THIS BULLETIN DOES NOT CHANGE AIRCRAFT TYPE DESIGN

SUBJECT: M20V ALTERNATOR WIRING, MOUNTING AND SECURITY
[Chapter 24 - ELECTRICAL POWER]

MODELS/ SN Mooney M20V - 33-0001 THRU 33-0018
AFFECTED:

Figure SB M20-340-1 - EXISTING ALTERNATOR WIRE ROUTING

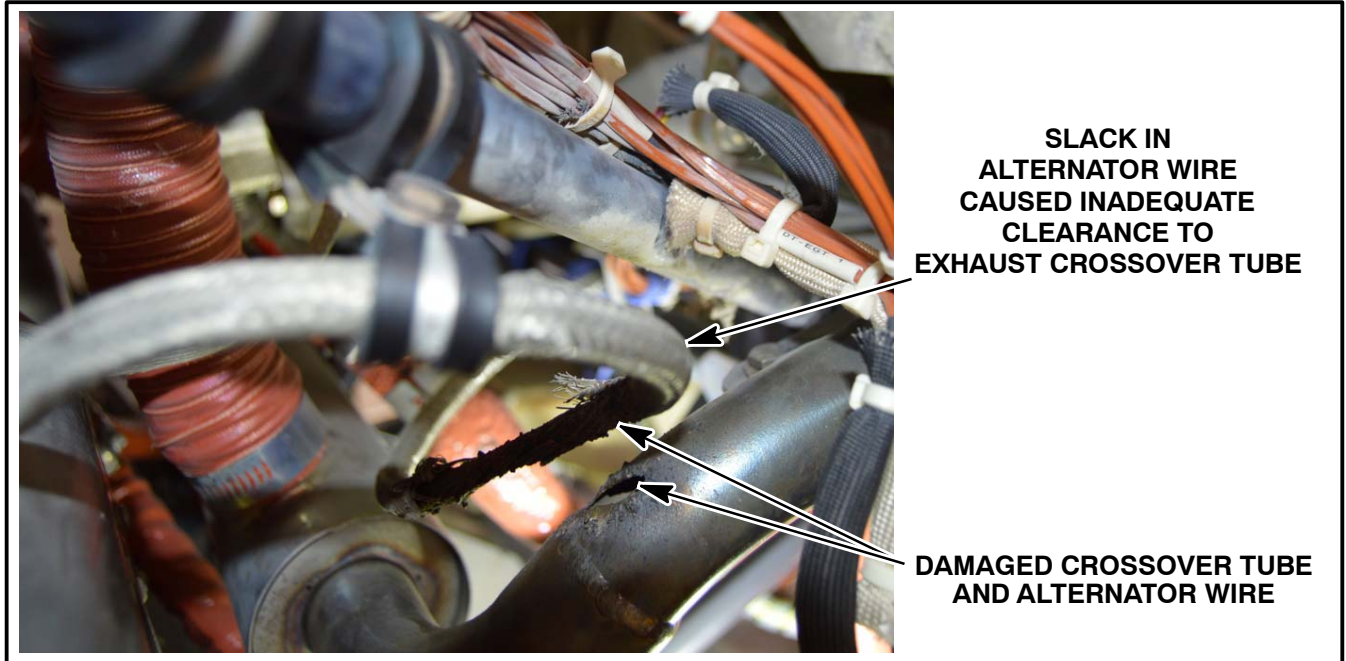
INTRODUCTION: There was a report in the field, of an M20V Acclaim Ultra with an alternator wire damaged on the RH exhaust crossover tube. Mooney Engineering has determined the wire was incorrectly positioned. This allowed the wire to contact the RH exhaust crossover tube causing a short circuit to the alternator. This resulted in damage to the wire and crossover tube. This requires mandatory compliance by owners. **The attached compliance card needs to be filled out and returned to Mooney International Corporation upon completion of this Service Bulletin M20- 340A.**

- 1.1. Turn master switch - OFF.
- 1.2. Remove top and bottom cowling, refer to Mooney Service and Maintenance Manual.
- 1.3. Locate upper alternator wire (refer to Figure SBM20-340-1). Inspect wire for any signs of damage; chafing, cracks in shielding, burnt spots, etc., if wire is damaged, contact MOONEY TECHNICAL SUPPORT support@mooney.com for a replacement wire.

- 1.4. Locate RH exhaust crossover tube. Inspect for damage; holes, cracks, etc., if damaged contact MOONEY TECHNICAL SUPPORT support@mooney.com for a replacement crossover tube, refer to Figure SBM20-340-1.

Figure SB M20-340-2 - ALTERNATOR WIRE ROUTING LOCATION (RH ENGINE MOUNT)

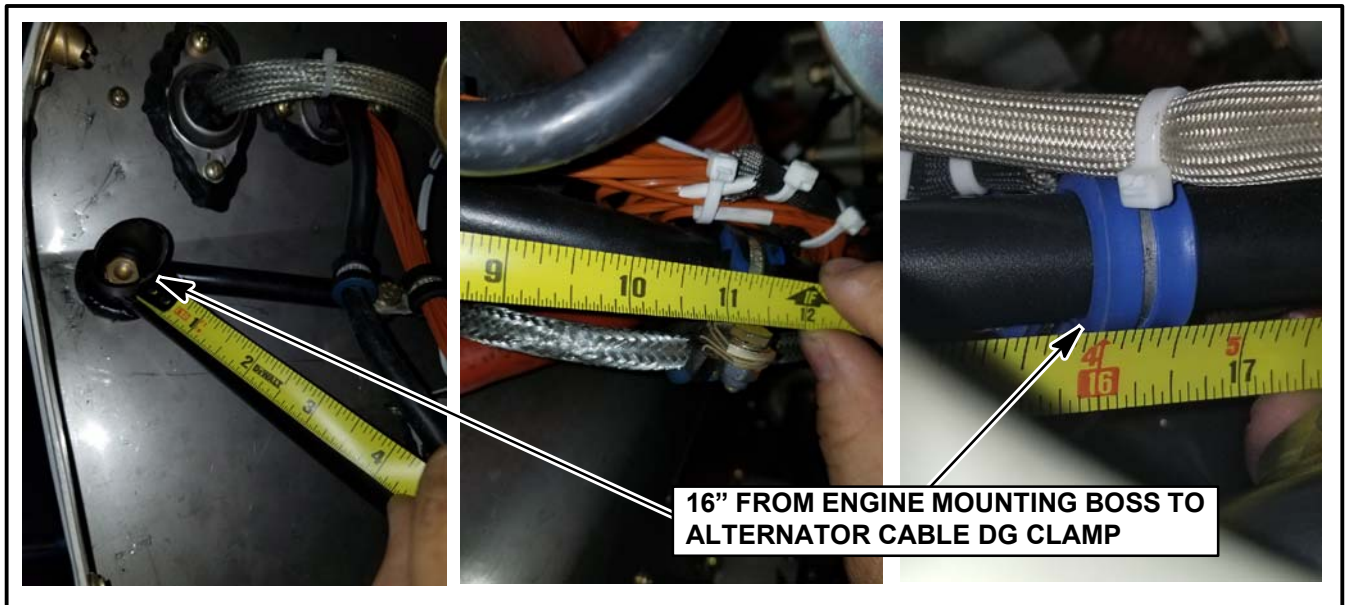
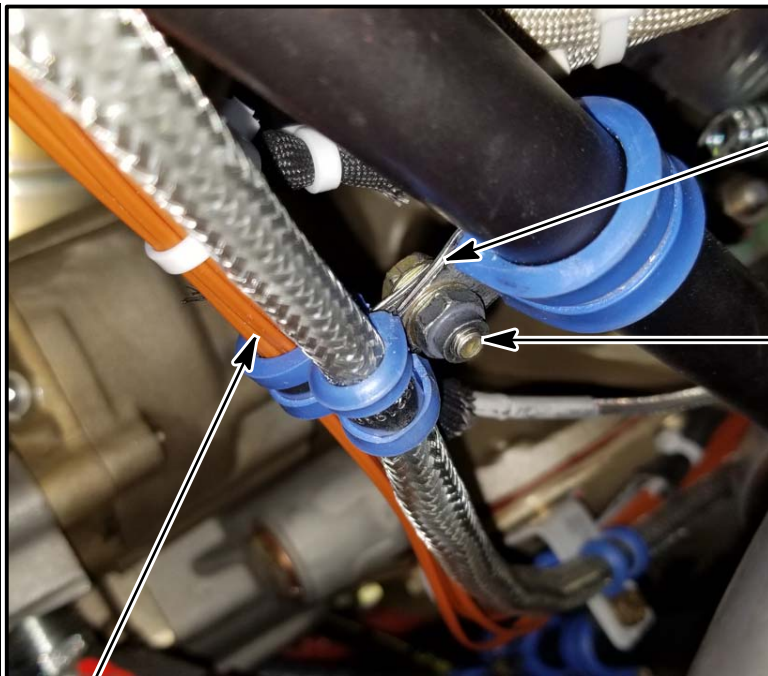
- 1.5. From RH engine mount mounting boss, measure along engine mount tube approx 16" to locate DG clamps mounting alternator field sensor wires to engine mount, refer to Figure SBM20-340-2.
